ALERT SERVICE BULLETIN

EQUIPMENT AND FURNISHINGS - Emergency floatation system
Inspection of the floatation balloon supply hoses

ASB AS350 25.04.10

TITLE: EQUIPMENT/FURNISHINGS (ATA 25)
EMERGENCY FLOTATION SYSTEMS
INSPECTION OF FLOAT SUPPLY HOSES

Figure 1

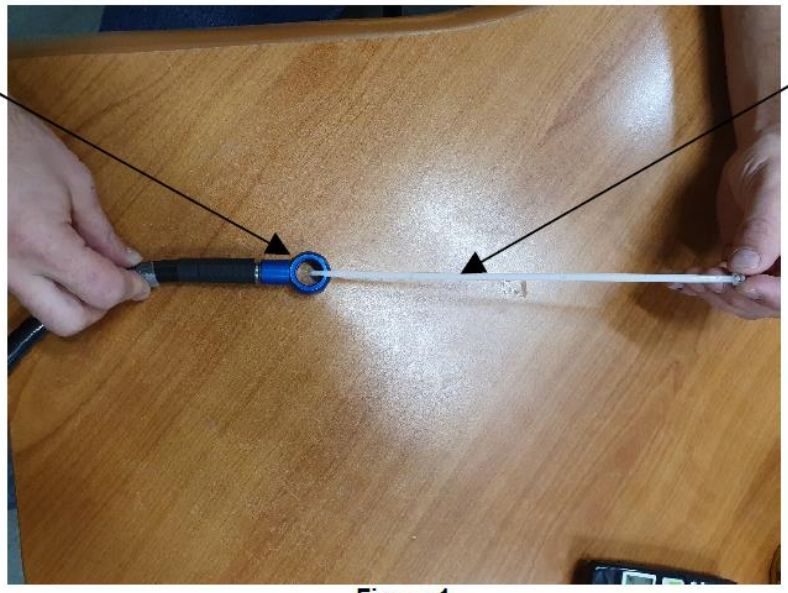
(a) Insert the end of plastic cable tie in the hole of outlet fitting (or banjo) (refer to Figure 1):

- If the cable tie goes through the fitting (or banjo) freely up to a minimal length of 300 mm (11.811 in), the hose is fully operative (refer to Figure 2),
- If a blockage occurs in the duct of the fitting (or banjo), the hose is blocked internally and must be replaced:

(a) For each section of the hose to be inspected, insert the end of plastic cable tie in the hole(s) of related fitting (or banjo) (refer to Figure 1):

- If the cable tie goes through the fitting (or banjo) freely up to a minimal length of 300 mm (11.811 in), the hose is fully operative (refer to Figure 2),
- If a blockage occurs in the duct of fitting (or banjo), the hose is blocked internally and must be replaced:
  - *If your material is Part 145 (in-service equipment and spare component)* related:
    Please contact Safran Aerosystems Services to get a replacement part.

(b) After inspection, identify the hose inspected and found operative by applying a visible green "dot" on the base of the verified outlet fitting (or banjo) with a green Dykem mark & code pen ref. 84007 (or equivalent indelible green marking).
